**NOTICE OF MEETING**  
**Building Appeals & Advisory Board**  
**Monday, May 20, 2019**  
**Planning/Code Conference Room – 2nd FLOOR**  
**285 UPTOWN BLVD., BUILDING 100**  
**7:00 p.m.**

**ORDINANCE NO. 2019-**

**AN ORDINANCE OF THE CITY OF CEDAR HILL, TEXAS ADOPTING THE 2018 INTERNATIONAL PLUMBING CODE; PROVIDING FOR THE REPEAL OF CHAPTER 4, ARTICLE VII, SECTIONS 4-116 THROUGH 4-117 OF THE CODE OF ORDINANCES OF THE CITY OF CEDAR HILL, TEXAS; PROVIDING A SAVINGS CLAUSE; PROVIDING FOR PENALTIES; PROVIDING A SEVERANCE CLAUSE; AND PROVIDING FOR IMMEDIATE EFFECT; AND PROVIDING FOR PUBLICATION.**

## Recommended Amendments to the 2018 International Plumbing Code

**Diagram 1003.1(1)**

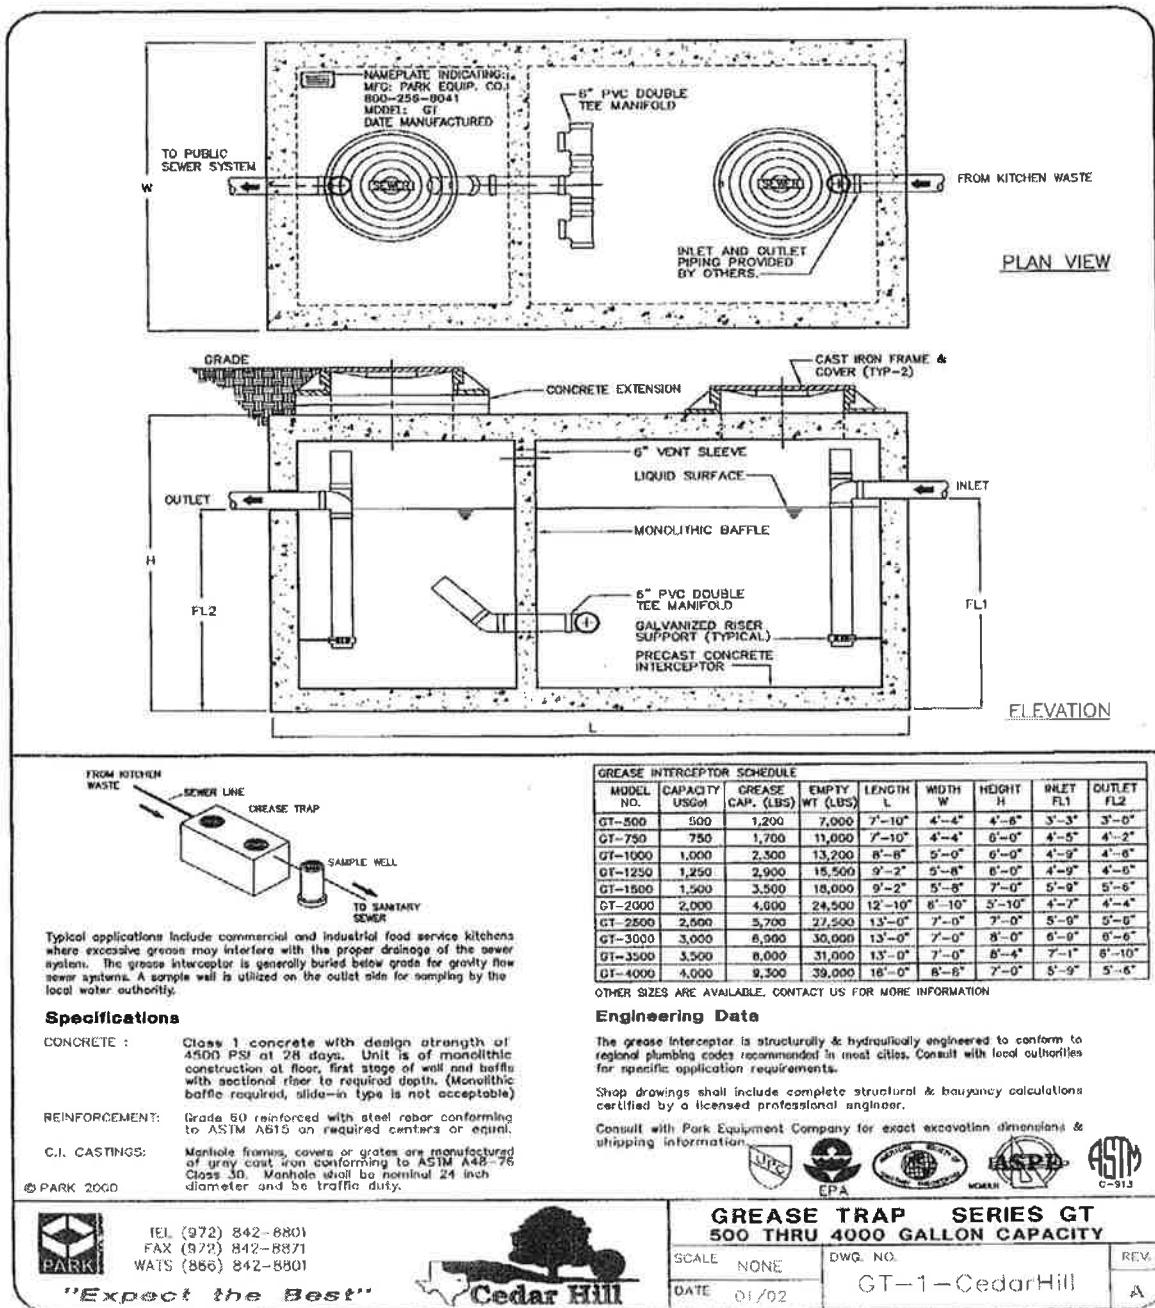
(55) Diagram 1003.1 is added as follows:

**Diagram 1003.1 Required style of grease interceptor.** All concrete grease interceptors shall be constructed to meet the design of Diagram 1003.1(1) and Diagram 1003.1(2).
